**PRELIMINARY/ FINAL DRAINAGE REPORT  
FOR RIVERBEND CROSSING FILINGS NO. 1  
AND 2**

SEPTEMBER 2018

PCD FILE NOS:  
SP 187  
SF 1843  
SF 1844

# INLET IN A SUMP OR SAG LOCATION

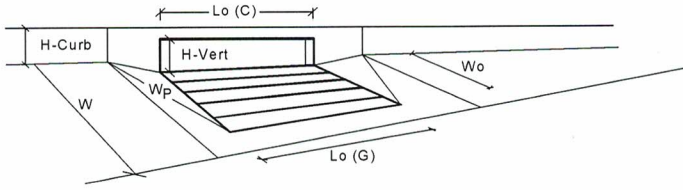
The inlet calculation for basin B7 indicates a 10' inlet. Revise the drainage map. Unresolved. Check all the other inlets for consistency.

REVISED TO MATCH CALCULATIONS

FIGURE A4 – Drainage Patterns as Depicted in the DBPS

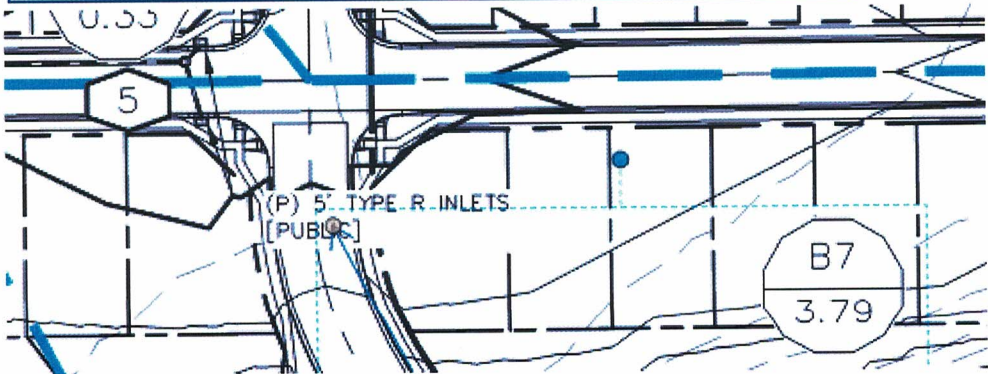
Add a north arrow.

**RIVERBEND CROSSING**  
**PROPOSED DRAINAGE PLAN**

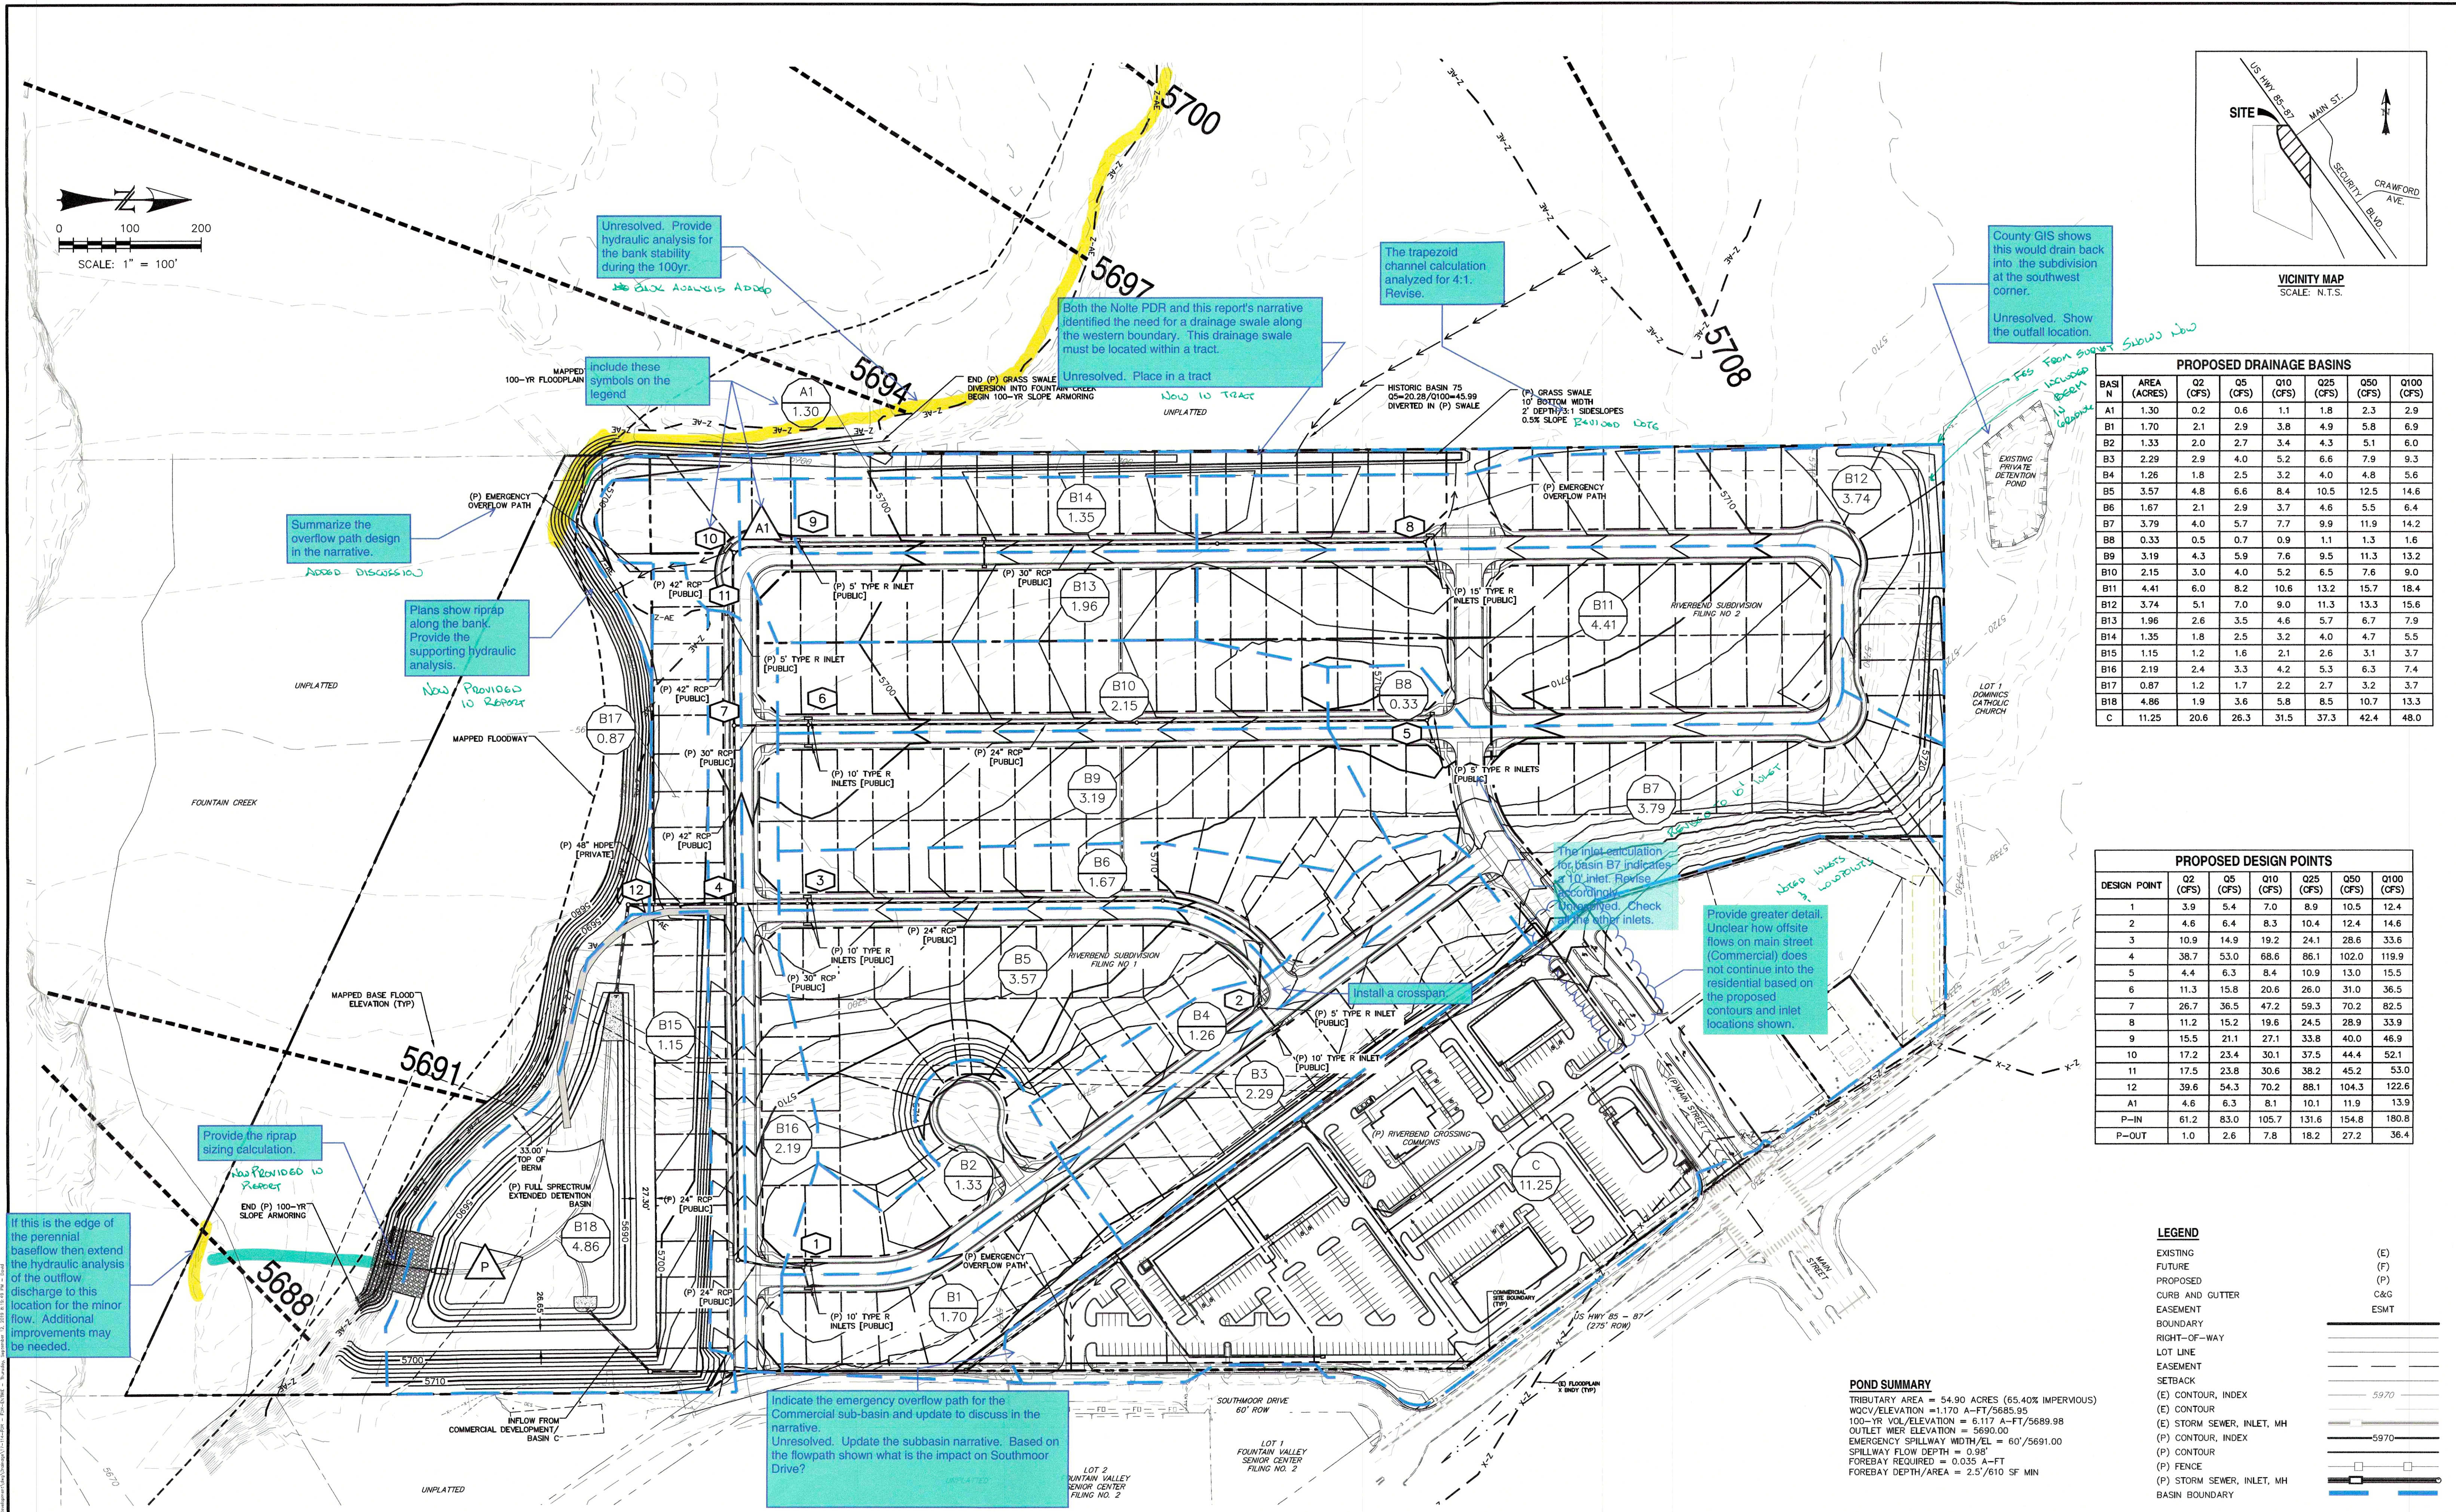
The drainage map is not clear how runoff is conveyed to pipe design point 12. The map does not show an area inlet. *ADDED DETAIL TO MAP.*
